# CVCWA Central Valley Clean Water Association

**SUBJECT: Tentative Waste Discharge Requirements for the City of Merced, Merced Wastewater Treatment Facility (NPDES No. CA0079219)**

Less than probability of differential TDS based annual average data from Region 5 POTWs (n = 36)

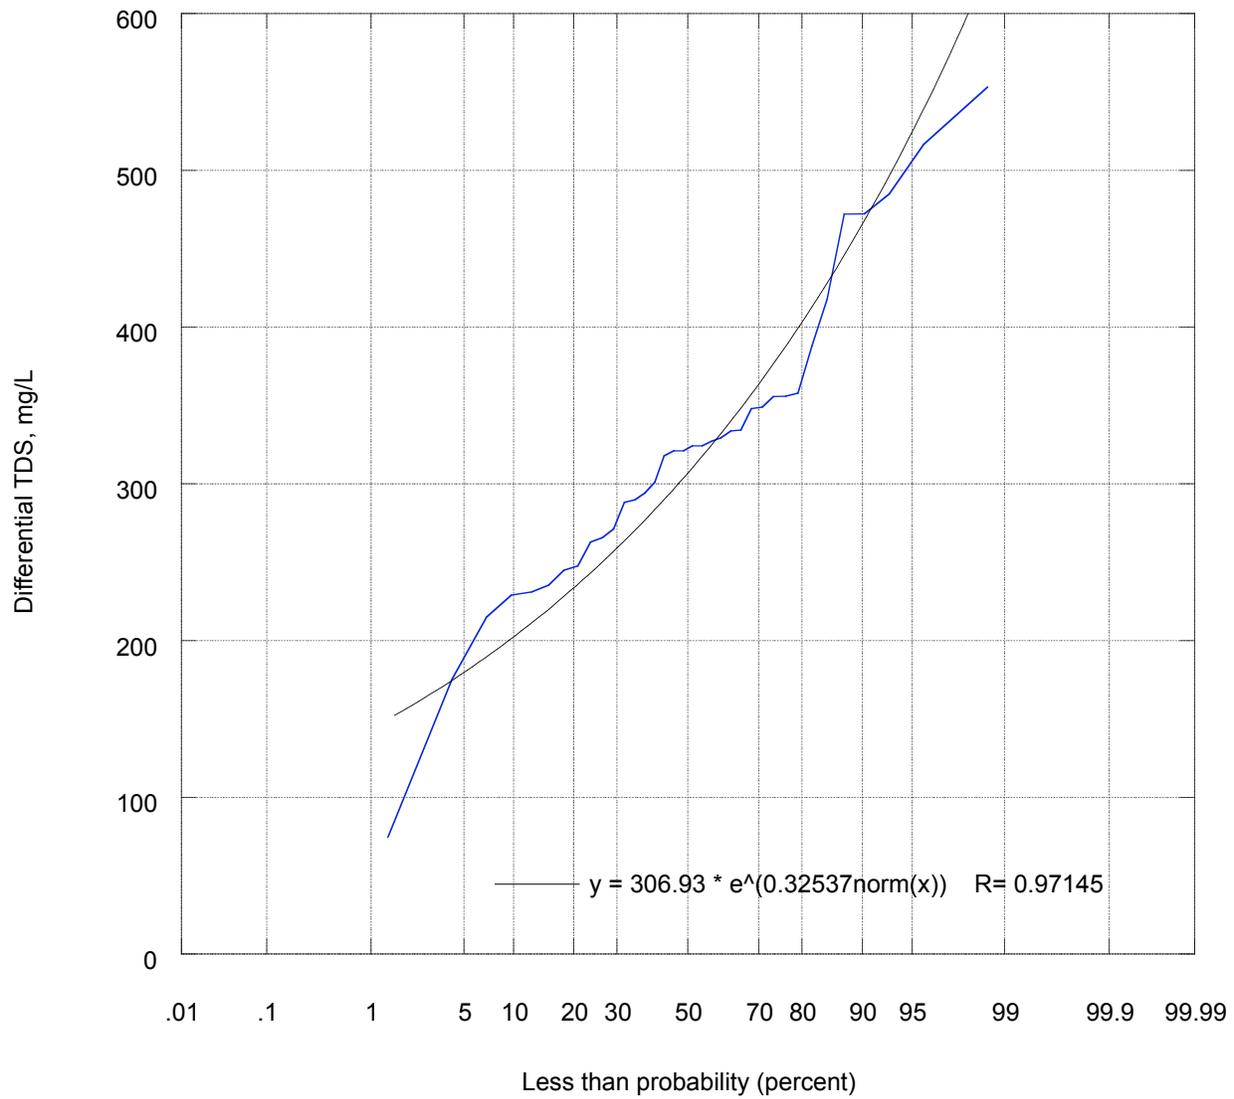
A recent survey of 74 POTWs in California (which includes 16 POTWs in the Central Valley) indicates that, on an annual average basis, the "salt increment" (measured as a TDS increment in the survey) was variable depending on the specific community in question. The results of the survey indicated that the median TDS increment in the Central Valley was approximately 320 mg/L (roughly equivalent to an EC increment of 530 umhos/cm), while the 95<sup>th</sup> percentile value was a TDS increment of 500 mg/L (equivalent to an EC increment of approximately 830 umhos/cm). Values from survey respondents for the remainder of the state were similar. The Central Valley survey results are depicted in the attached figure. Please note that the "n" value referenced in the figure is the number of data points (36) received from the 16 survey respondents.

We believe this information indicates that the proposed effluent limits for EC based on an EC increment above water supply are not reasonably achievable, are not "practicable" and should not be used in the City of Merced, or other NPDES permits. Instead, we believe the Regional Board should employ the approach used in other recently adopted Central Valley permits, establishing an interim, performance-based effluent limit for EC and requiring an aggressive salt management plan within the service area.
